# SITE PLAN REVIEW

LOT NO 7 REGISTERED PLAN

PROJECT/LOCATION  
**RIVERWALK, PHASE 2  
BRAMPTON, ON**

DRAWING  
**SITE PLAN**

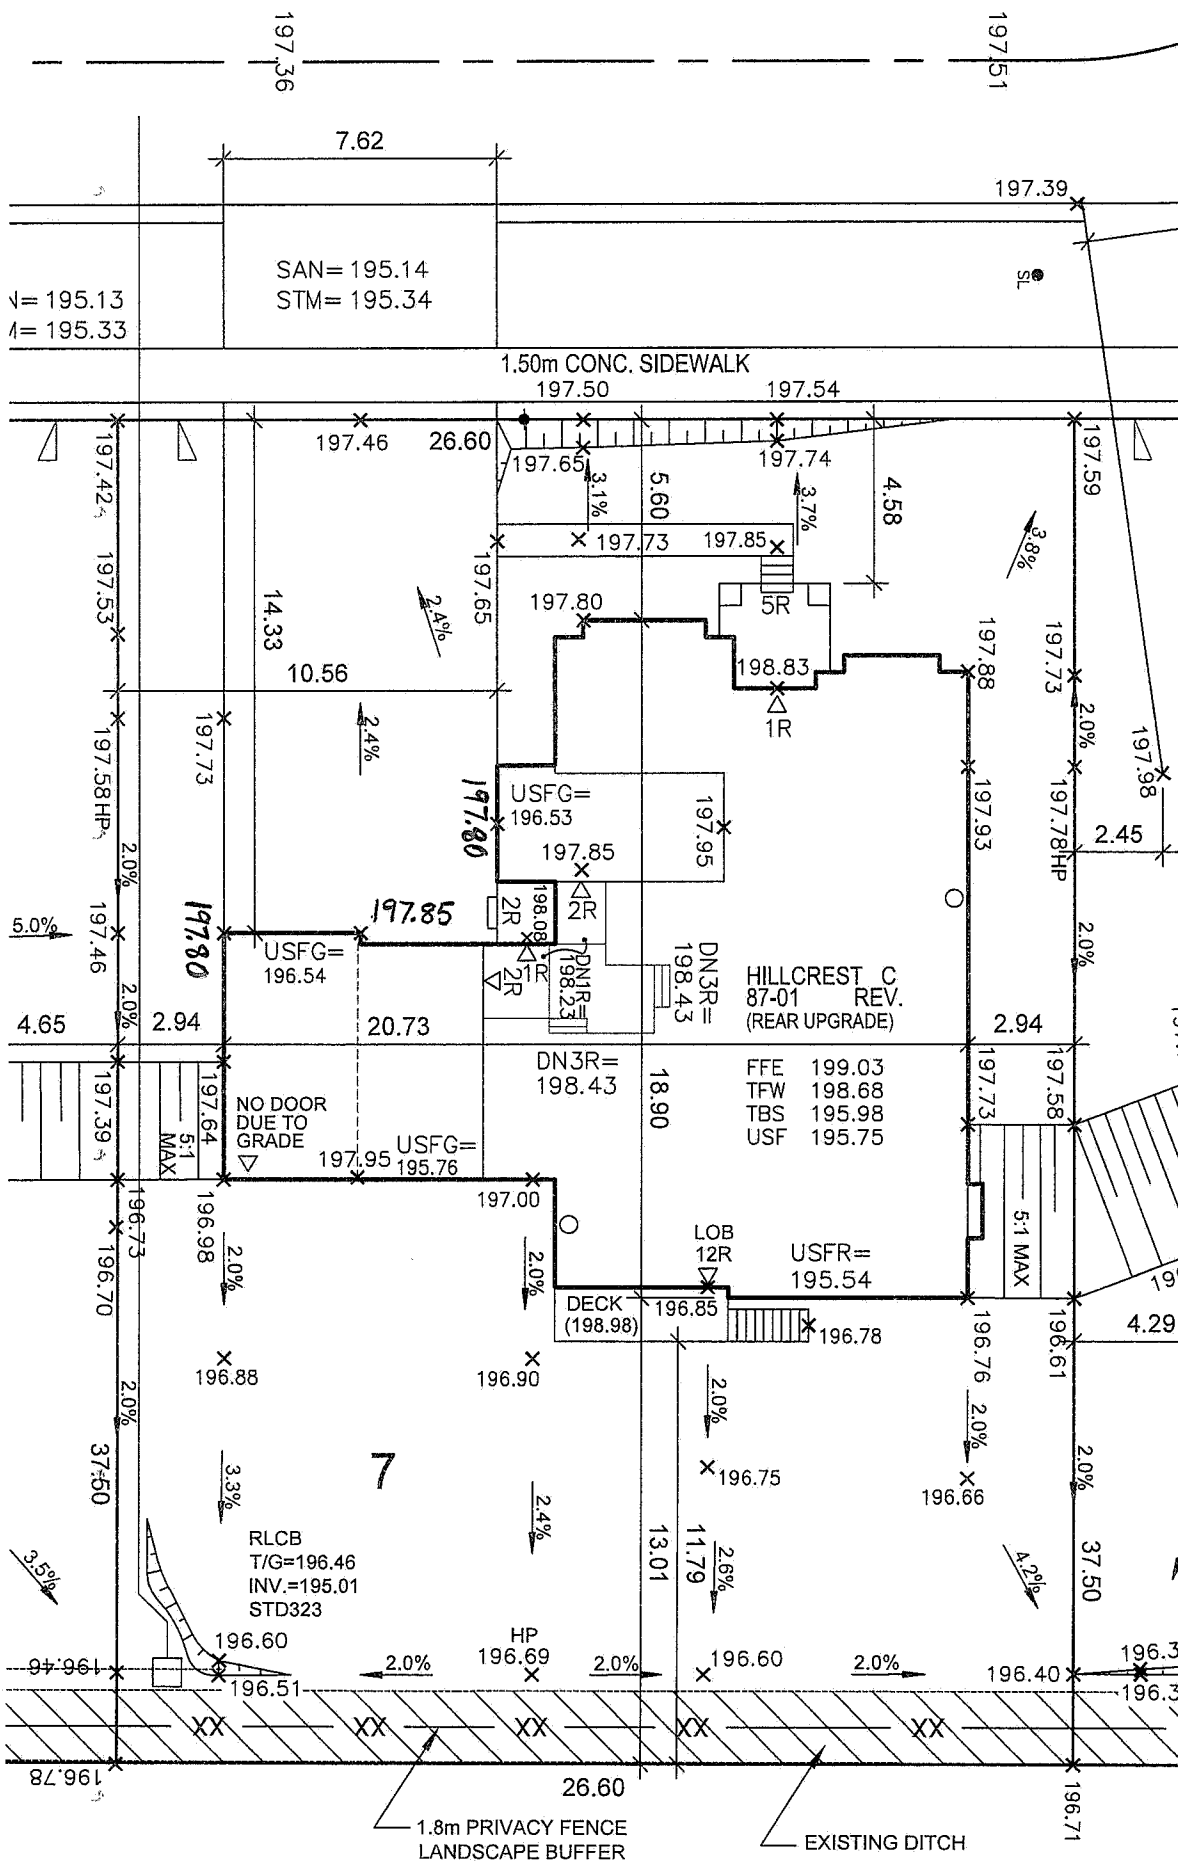
THE PROPOSED LOT GRADING AND DRAINAGE IS APPROVED AS BEING IN CONFORMITY WITH THE OVERALL APPROVED GRADING PLANS FOR THE SUBDIVISION.
